***TRANSITIONAL PART 3A ASSESSMENT  
Concept Plan Modification MP05\_0086 MOD 4  
and  
Project Application MP11\_0046  
for  
Stage 3 Residential Development, Buildings  
11 to 17 at 61 Mobbs Lane, Epping  
(Former Channel 7 Site)***

Director-General's  
Environmental Assessment Report  
Section 75I of the  
Environmental Planning and Assessment Act 1979

May 2013

**Figure 10:** Comparison of Approved and Proposed Building Envelopes  
(pink envelopes depict the envelopes approved under MP05\_0086 MOD 2)

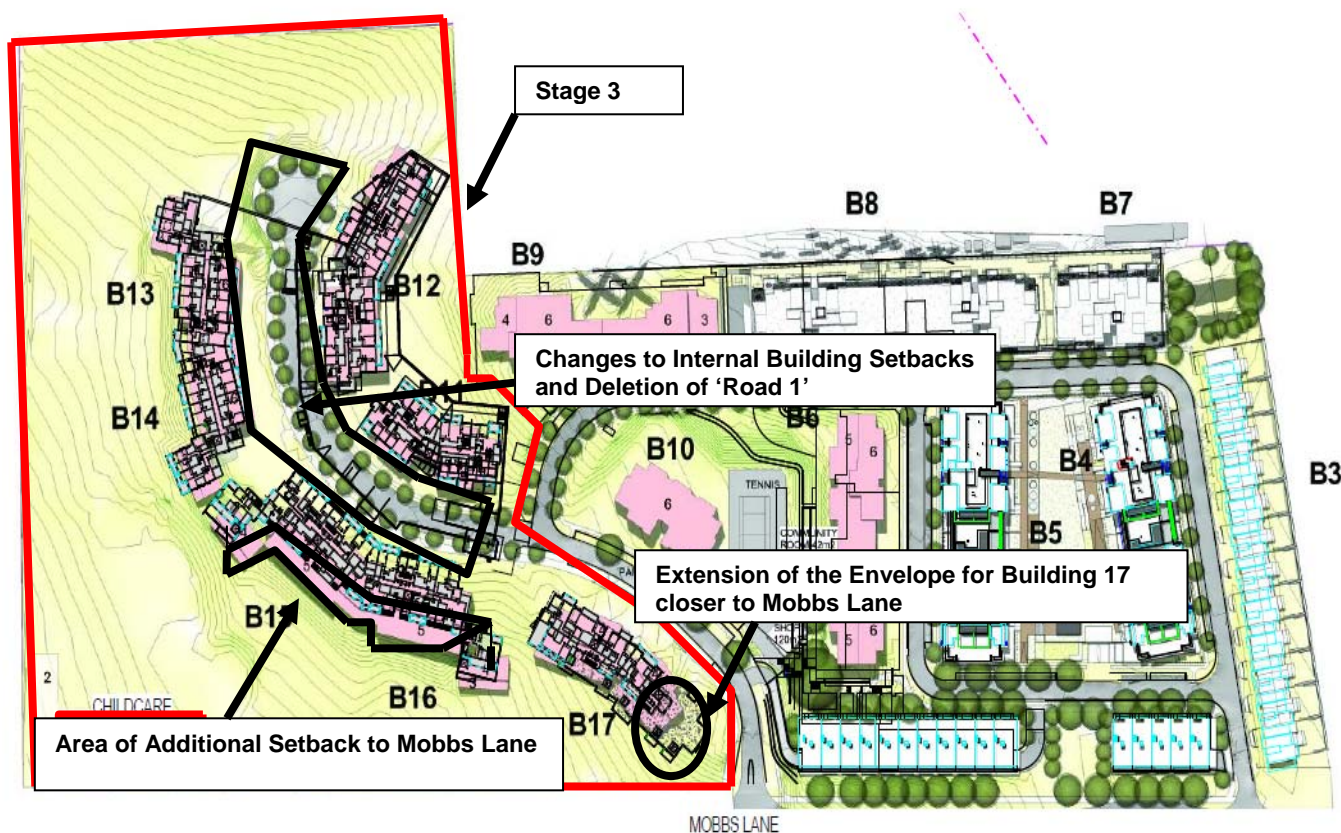
- Reconfiguration of the southern and western elevations of Building 12;
- Increasing the height of the wings adjacent to the south-western and south-eastern corners of Building 13/14 from part three, part four-storey to wholly four-storey;
- Relocation of Building 15/16 to the north of its approved location; and
- Elongation of Building 17, and a reduction in its setback to Mobbs Lane;

**Figure 10** provides a comparison of the approved and proposed building envelopes and **Figure 11** depicts the height requirements outlined in the Concept Plan.

The department has reviewed the proposed modifications to the building envelopes and supports the relocation of buildings 11 and 12 and 13/14 on the basis that the modified building envelopes would remain compliant with the minimum building separation distances recommended in the *Residential Flat Design Code* and would not result in any adverse amenity impacts when viewed from Mobbs Lane or the adjoining reserve. In addition, the department supports the proposed modifications to the envelope of Building 15/16 on the basis that the modifications will increase the separation between the six storey components of the building and Mobbs Lane by approximately 8 metres (creating a total setback of between 48 metres and 85 metres for the six storey component of the building).

The department does not support the proposed modifications to the envelope of Building 17 on the basis that the above ground portion of the basement, the podium, and the north-eastern corner of the building are not sufficiently setback from Mobbs Lane to mitigate the bulk and scale of the development (setback of 15 metres to the eastern wall of Building 17 currently approved, 4.7 metres to the edge of the elevated podium and 7 metres to the balconies on the eastern elevation of Building 17 proposed).

In order to resolve this issue, the department has recommended conditions requiring the proponent to:

- Ensure the aboveground portion of the basement car park and the podium are setback 8 metres from Mobbs Lane. This will ensure appropriate landscaping can be installed to soften the bulk and scale of the building; and
- Redesign apartments UG84, UG85, U184, U185, U284 and U285 (adjacent to the eastern elevation) to remove the balconies and bedroom 1 of each apartment so that an appropriate setback is provided to Mobbs Lane (see **Figure 12**).

**Figure 12:** Portions of Building 17 to be Redesigned

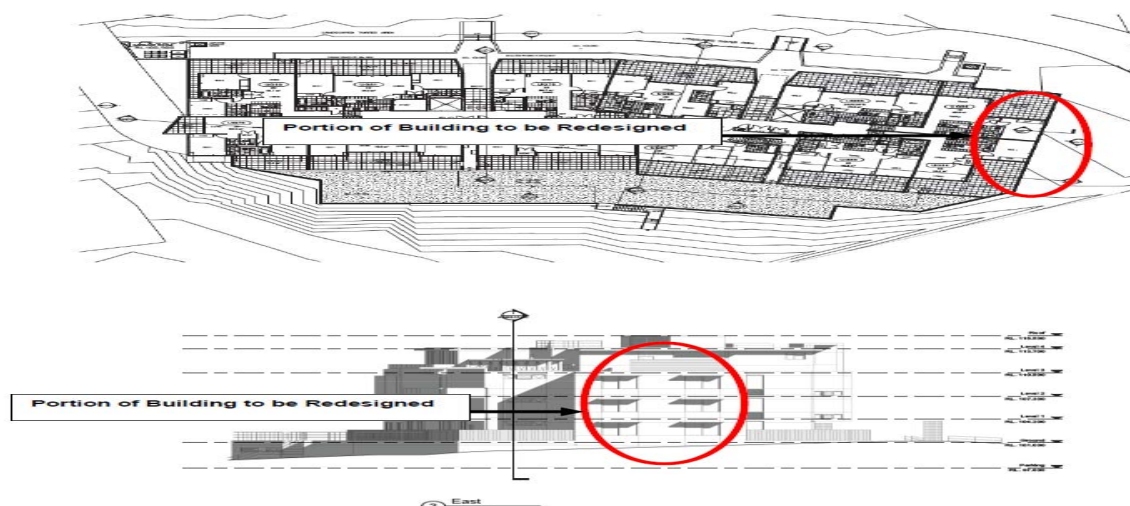
The department notes that the redesign of apartments UG84, UG85, U184, U185, U284 and U285 would result in the loss of three apartments (one on each level). In this regard, the department considers that it would be possible to 'recover' these apartments by utilising the residual floor space available within the wings on the south-eastern and south-western ends of Building 15/16 (see **Figure 13** below). The department has recommended conditions to facilitate the recovery of these apartments whilst ensuring compliance with the unit mix and car parking rates specified in the Concept Plan and the requirements of SEPP 65.
